**EVALUATION OF A SELECTED SITE FOR A PROPOSED
JOPLIN WATER SUPPLY RESERVOIR ON BAYNHAM BRANCH**

PHASE 1 REPORT

December 29, 2020

**Thomas Aley, Missouri Registered Geologist 0989
Senior Hydrogeologist and President
and
David Woods, Senior Project Scientist
Ozark Underground Laboratory**

Figure 2. Losing streams in the reservoir area.

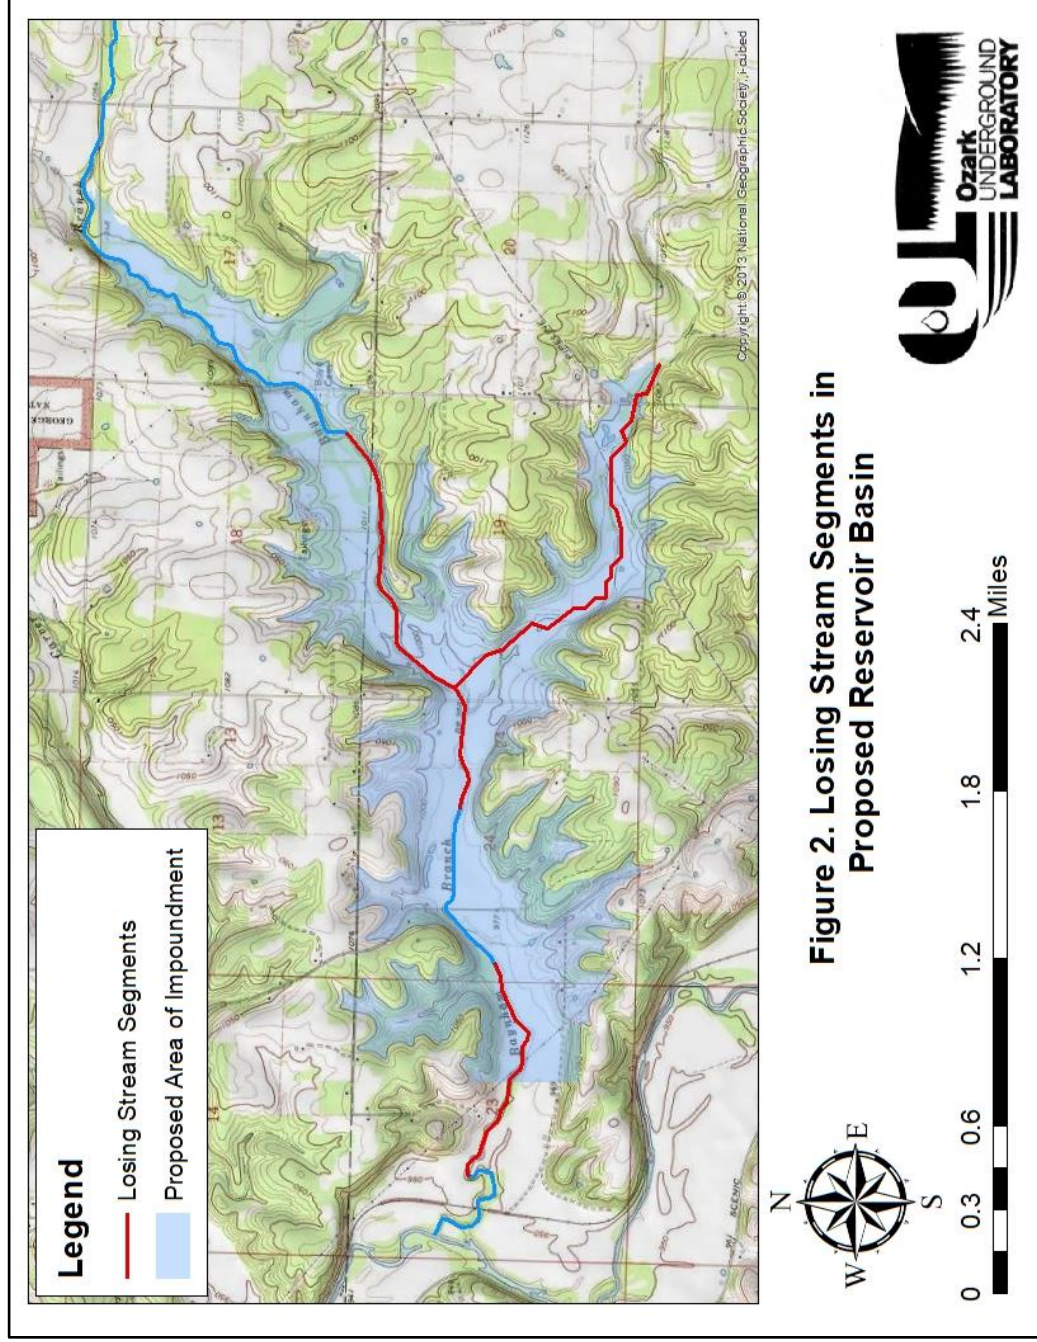
Figure 2 shows stream segments in the proposed reservoir area that are losing streams under the EPA definition. In other words, they are streams that contribute directly to groundwater. The total length of losing stream segments in the proposed reservoir area is 19,200 feet; total perennial stream length in the proposed reservoir is 9,800 feet. Losing streams are thus 66% of all main stem stream channels in the proposed reservoir area. This mapping is by the OUL and there are three principal losing stream segments:

The MAWC Proposal (page 16) states that there are 3,488 linear feet of losing stream segments in the proposed impoundment area and further states that: *“The losing stream would be entirely inundated by the proposed reservoir and is not anticipated to impact reservoir storage.”* This conclusion is wrong and without any factual support. OUL work discussed in the next section of this report shows that the proposed impoundment area, even without a reservoir, already experiences major groundwater transport to springs outside of the area proposed for impoundment.

Figure 8. Diagram of groundwater flow routes for rhodamine WT dye introduced into the Gary Dug Well.

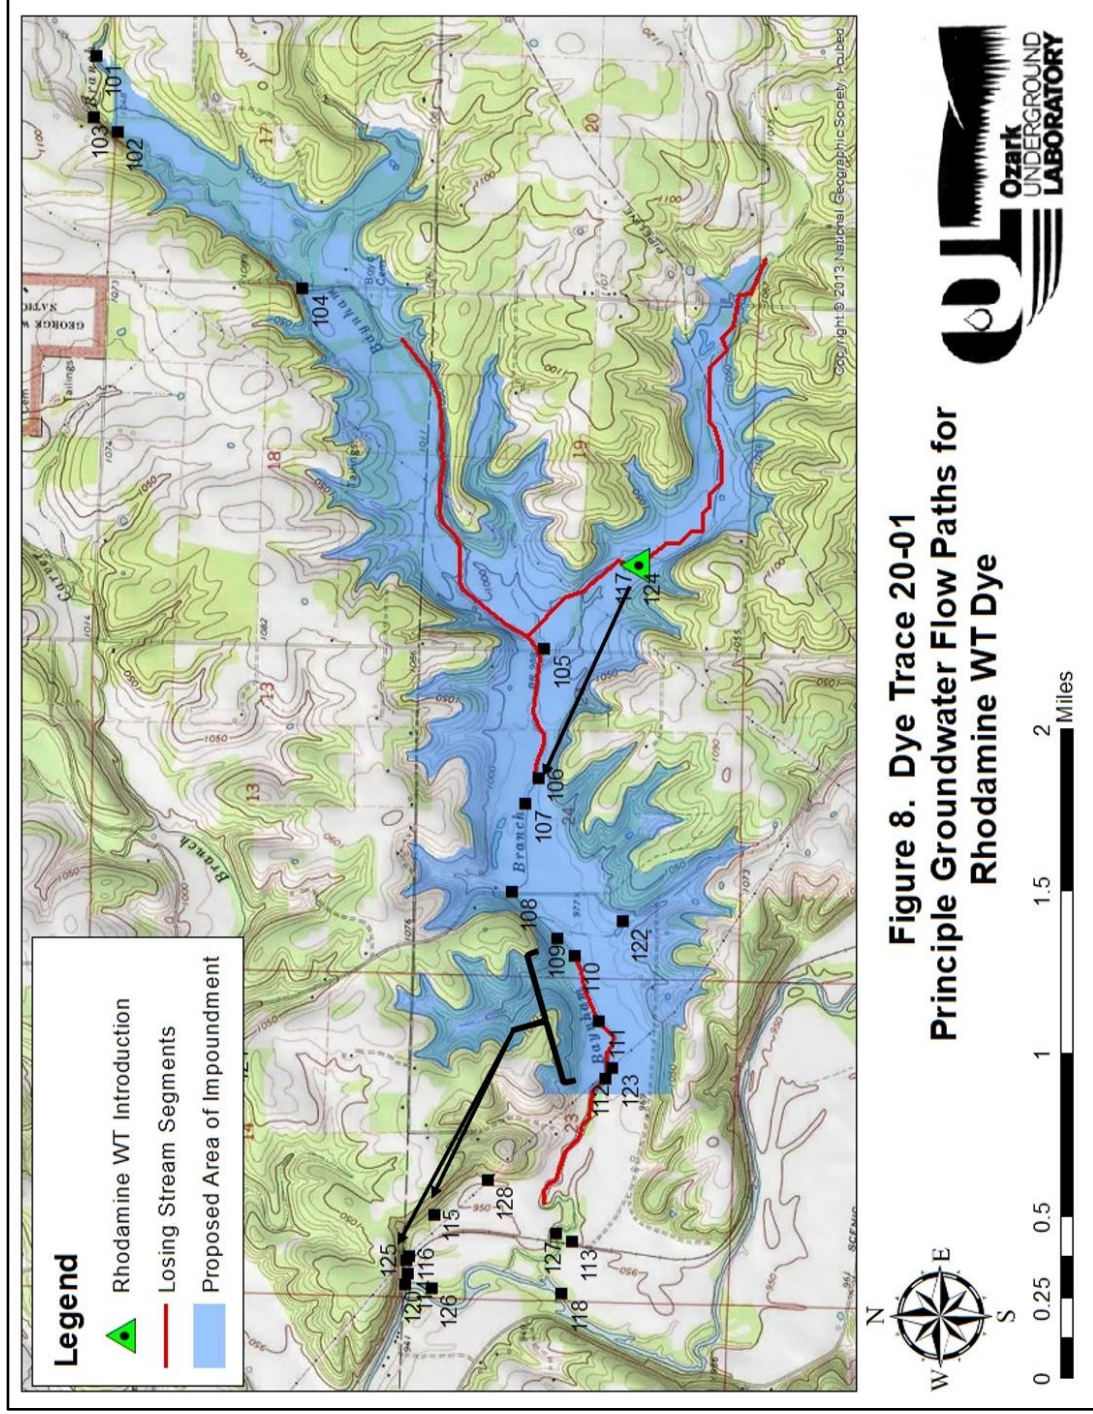
Figure 8 is a diagram of flow routes for rhodamine WT dye introduced into the Gary Dug Well. Although not shown in Figure 8, an alternate flow route for rhodamine WT dye arriving at the Hunley Springs Complex would be entirely through groundwater from the Gary Dug Well to the Hunley Springs Complex. There is no way to prove or disprove this flow path from the tracing data collected during the OUL work. If this alternate flow route exists, Gary Dug Well, with a surface elevation of approximately 1005 feet, would be inundated by approximately 46 feet of water at normal pool and would probably be a significant point for reservoir leakage.

Figure 9. Diagram of groundwater flow routes for eosine dye introduced into Baynham Branch upstream of Carver Road.

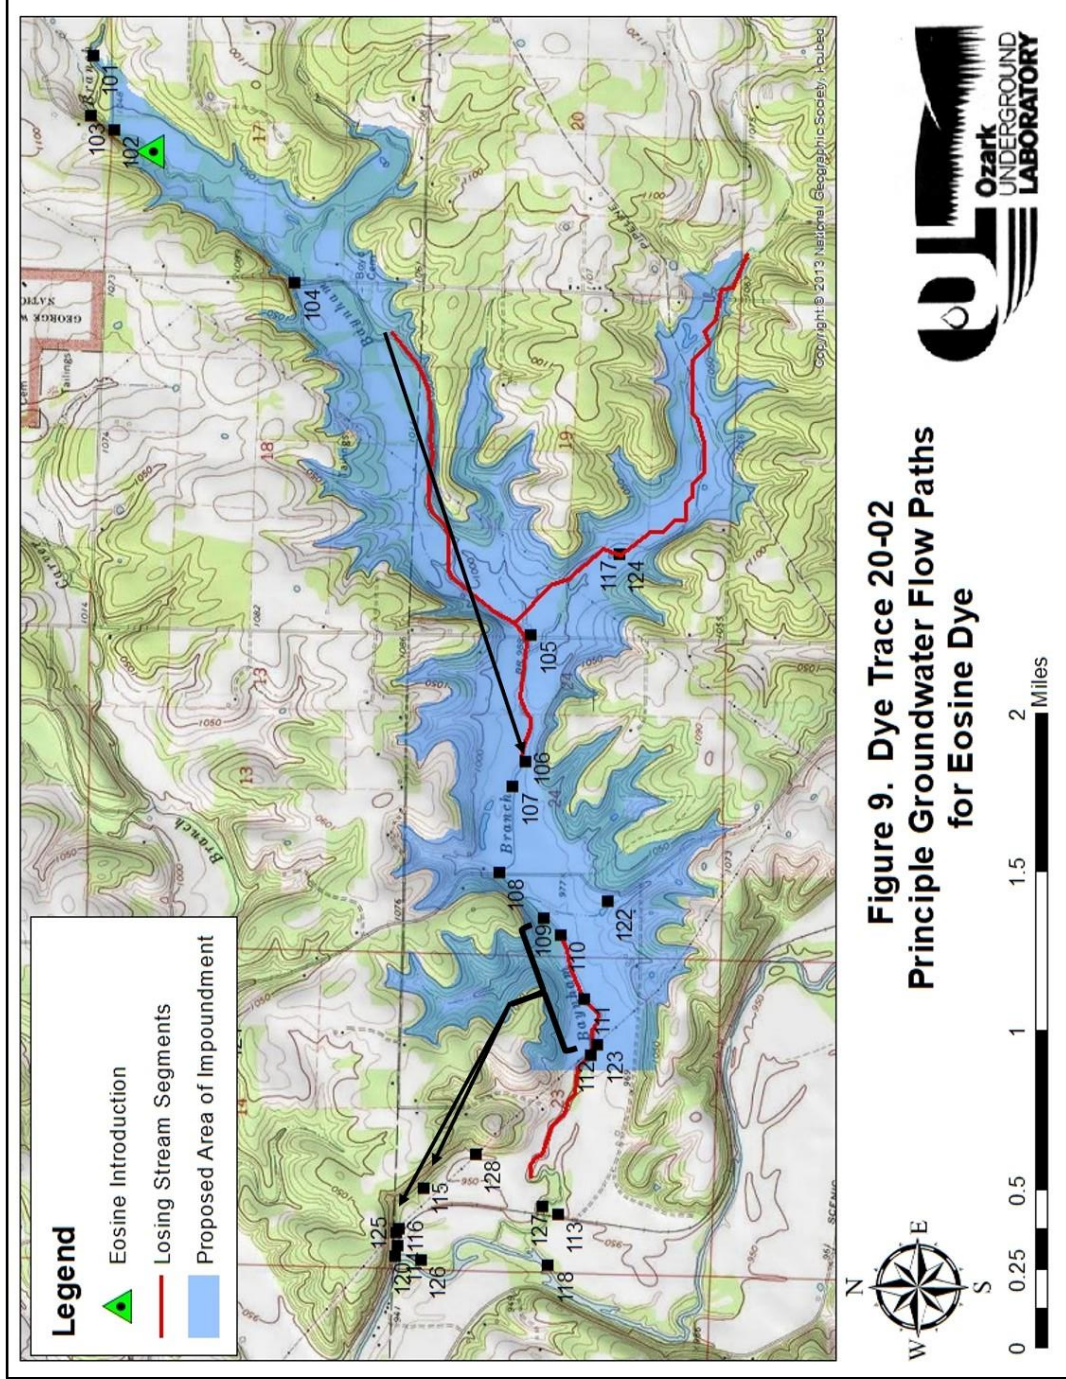
Figure 9 is a diagram of groundwater flow routes for eosine dye introduced into Baynham Branch upstream of Carver Road. Although not shown in Figure 9, an alternate flow route for eosine dye arriving at the Hunley Springs Complex would be entirely through groundwater from the sinking point downstream of the dye introduction point to the Hunley Springs Complex. There is no way to prove or disprove this flow path from the tracing data collected during the OUL work. If this alternate flow route exists it would probably be a significant zone for reservoir leakage since the sinking point is 45 feet below the planned normal pool elevation of the reservoir.

Figure 10. Diagram of groundwater flow routes for fluorescein dye introduced into Baynham Branch downstream of Lime Kiln Rd.

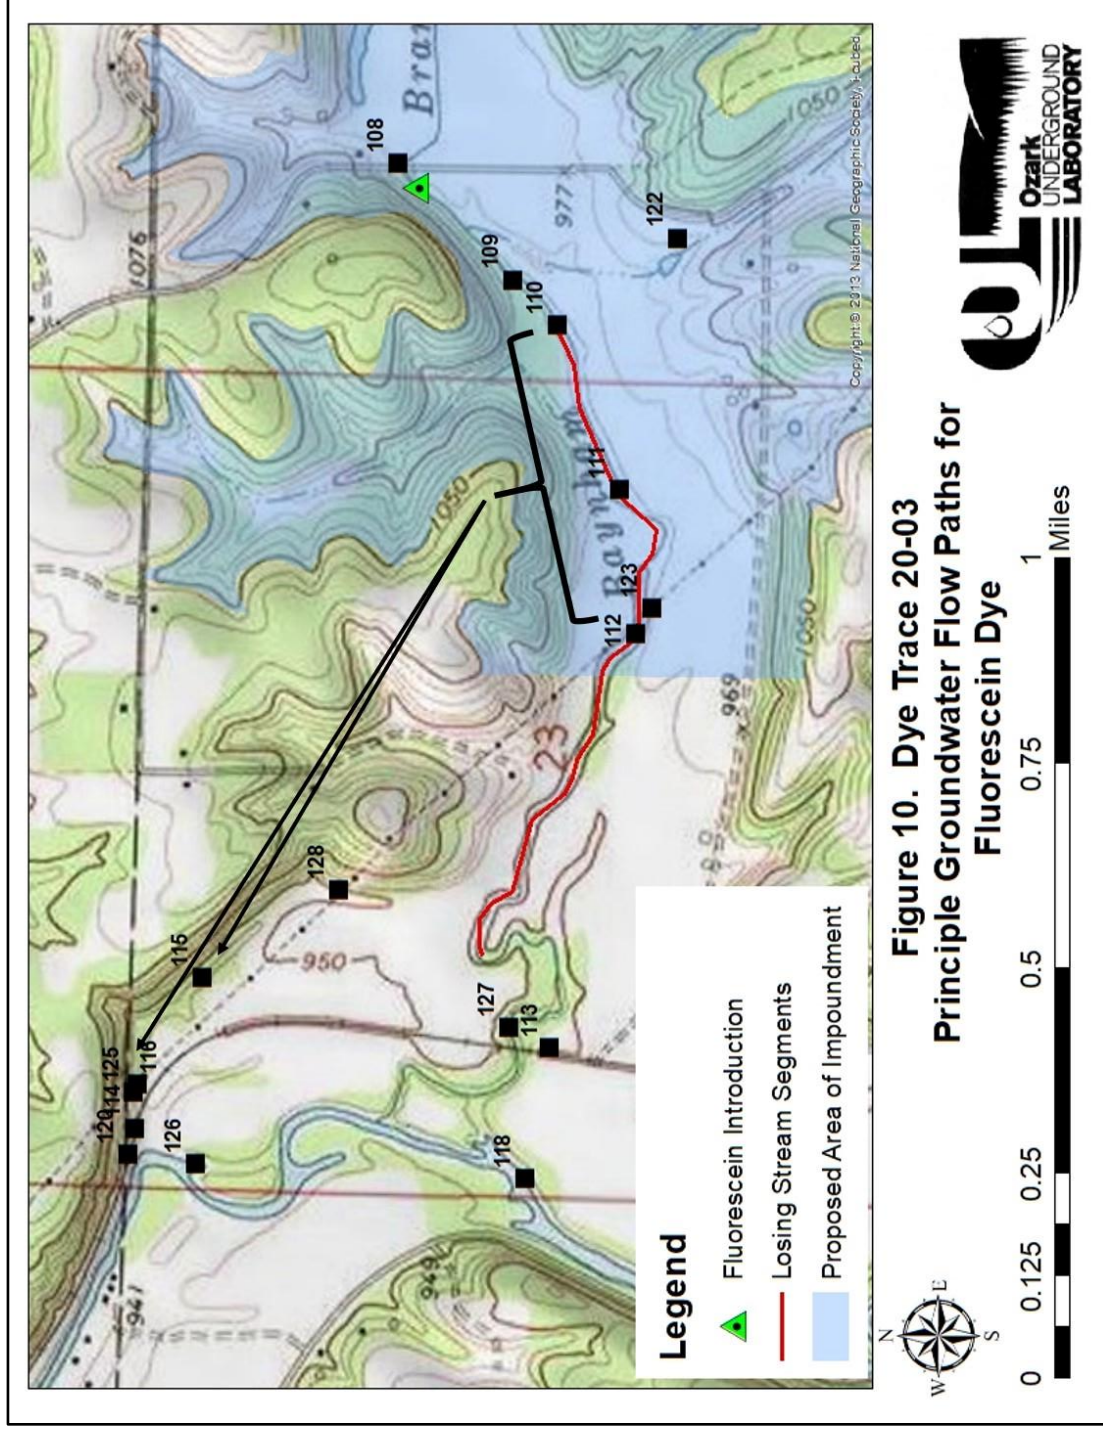
Fluorescein from Trace 20-03 was first detected in activated carbon samplers in place at Stations 114, 115, 116, and 127 in the Hunley Springs Complex for the period from October 22 to 29, 2020. The straight-line distance between the dye introduction point and dye detection Station 116 was 6,130 feet and the mean travel rate was greater than 875 feet per day. **Figure 10** is a diagram of the groundwater flow routes for fluorescein dye introduced into Baynham Branch at a point approximately 115 feet downstream of Lime Kiln Road. With a reservoir at the design water level elevation of 1,051 feet the depth of water over the leaking segments of Baynham Branch tested by the fluorescein dye introduction would vary from approximately 75 to 97 feet. This would dramatically increase leakage volumes through this segment of Baynham Branch upstream of the proposed dam.

Figure 11. Measured Flow Rates of Baynham Branch downstream of Lime Kiln Road on 10-8-2020.

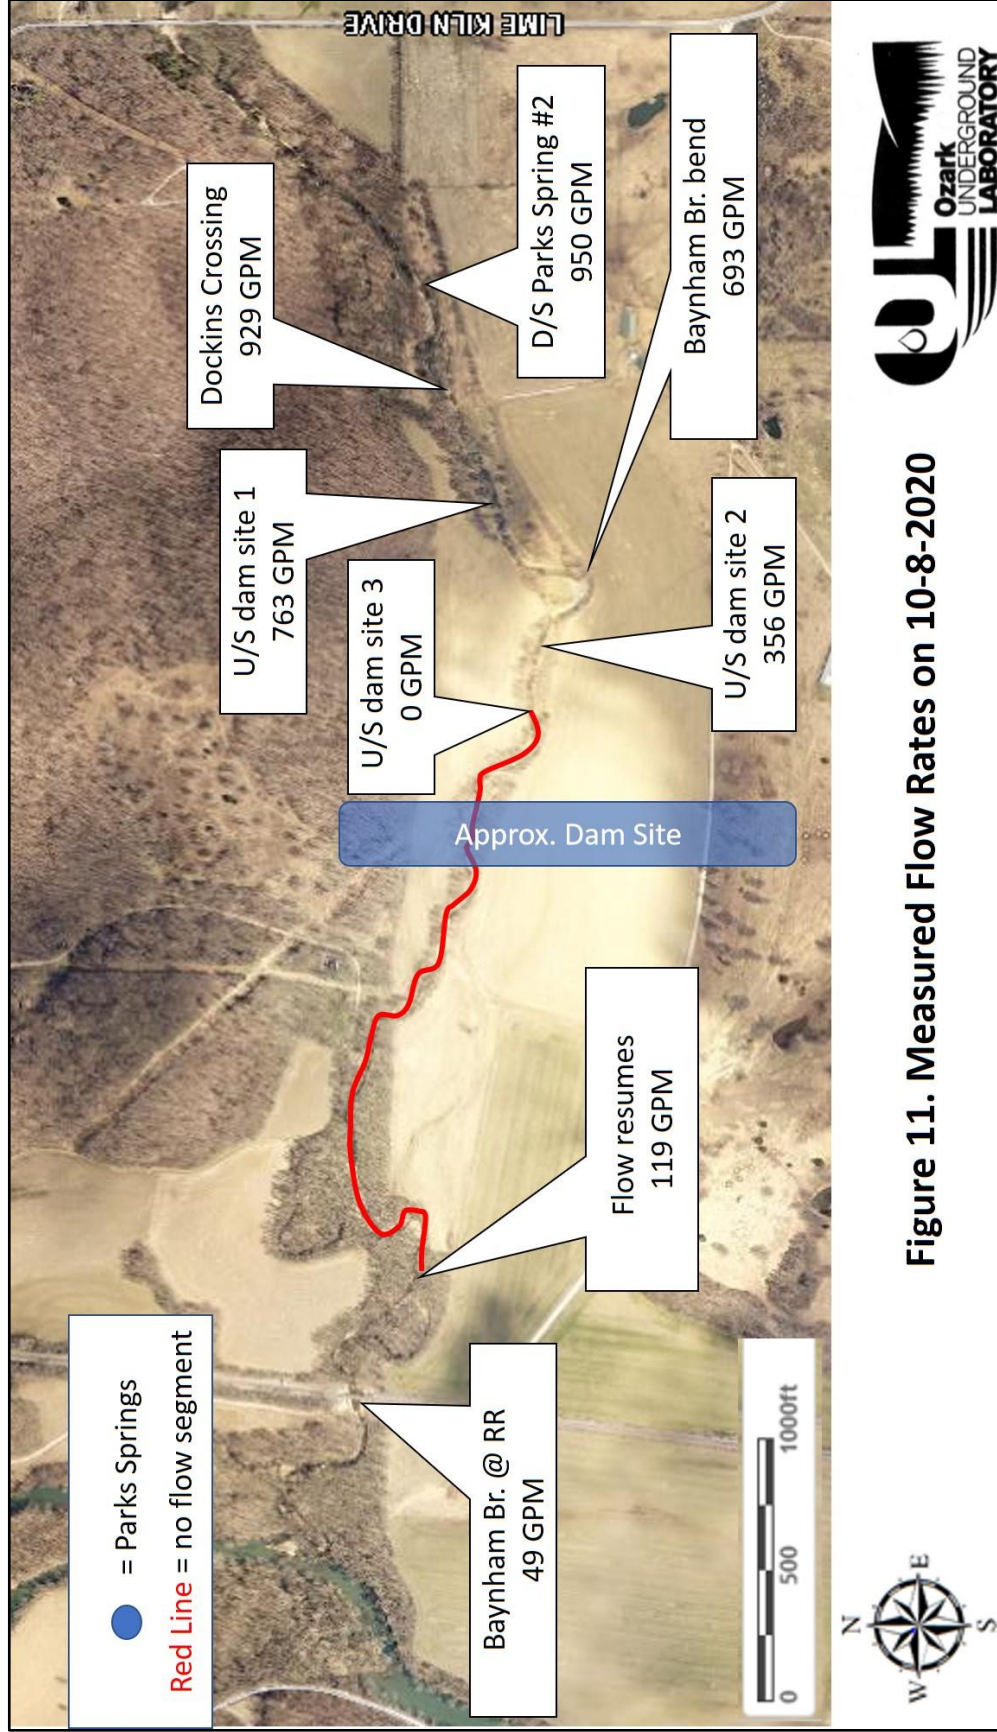
On October 8 and November 5, 2020, the OUL made a number of flow rate measurements and other observations in Baynham Branch between Lime Kiln Road and the railroad crossing of the stream (**Table 6**). The results show that no more than 5 to 20% of the flow lost upstream of the dam site could be accounted for by streamflow at the railroad crossing. Small dye detections at the railroad crossing indicate that much of the measured flow at this location was probably not water that was lost from the Baynham Branch channel upstream of the dam.

Figure 15. Bedrock irregularities in limestone under a leaking industrial wastewater lagoon in Pennsylvania.

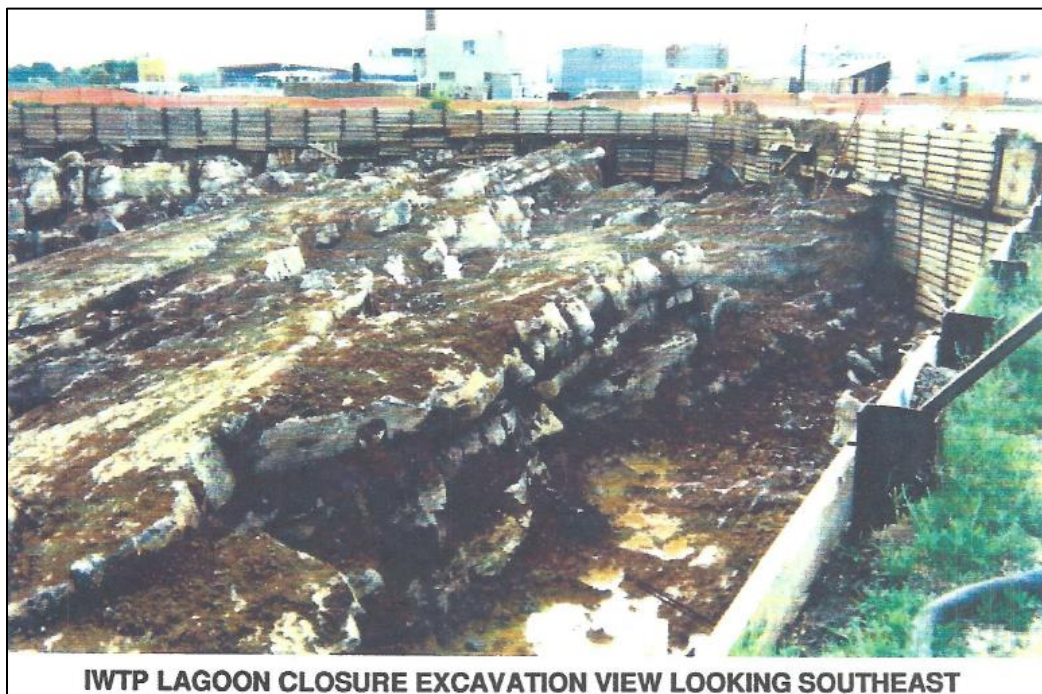
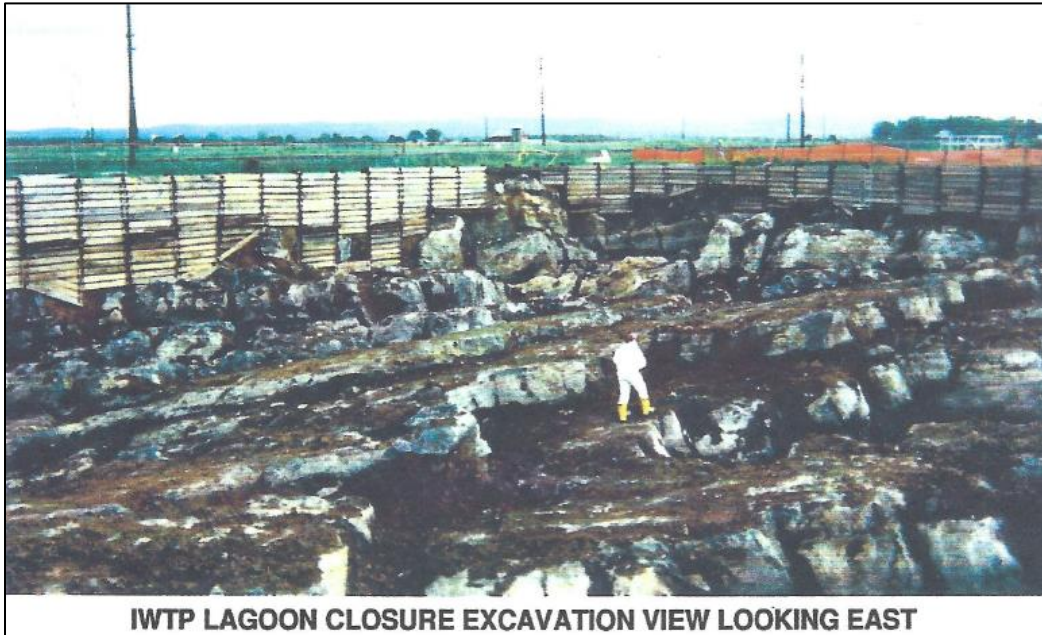
In the experience of the OUL the upper surface of the Burlington-Keokuk Limestones beneath losing streams is likely to present a highly irregular cutter and pinnacle topography such as described by Fellows (1965). Figure 15 illustrates these types of irregularities observed by the OUL during remediation of a leaking industrial wastewater lagoon in Pennsylvania. Not only does this create construction difficulties in excavations to key a dam into the bedrock, but solutionally enlarged openings in the bedrock sufficiently large to permit turbulent flow and sediment transport are common. These features can extend to substantial depths in the area due in part to the extensive paleokarst development associated with the Tri-State mining district, which includes Newton County. The zinc and lead deposits in Newton County were localized in karst features that were probably of hypogenic origin. This mode of origin is consistent with relatively high permeability in the Burlington-Keokuk Limestones and in the
